RECALL NOTICE

IC CORPORATION RECALL # 03306 NHTSA RECALL # 04V-010 February 2004

Modesty Panel at Front Barriers

Area where panel may be bent out of position.

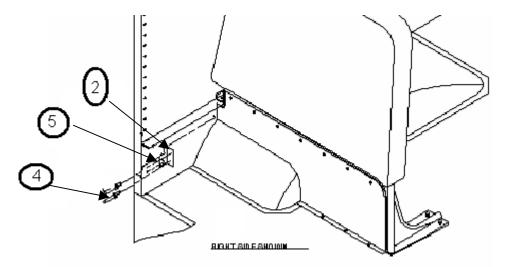
The steel modesty panel that is installed under the seat barrier behind the driver seat and behind the entrance door is cutout to clear the wheel well. This cutout allows the lower portion of the panel to be bent out of position leaving a gap between the wheel-well and the lower edge of the modesty panel at the cutout area. The edge of the cut out is protected with snake rubber (protective edging). If the snake rubber is knocked off of the edge of the panel, a raw edge is exposed facing down.

This repair procedure involves adding a bracket at the wall to secure the end of the modesty panel. This must be done to the panel on both sides of the bus.

- 1. Locate the angle (item #2) centered vertically with the end of the panel.
- 2. Install angle onto wall with two self-drilling screws (item #5).
- 3. Using a 1/8-inch drill bit, drill two holes through the angle and modesty panel.
- 4. Fasten angle to modesty panel with two (2) of item #4 –(rivet, pop 1/8")
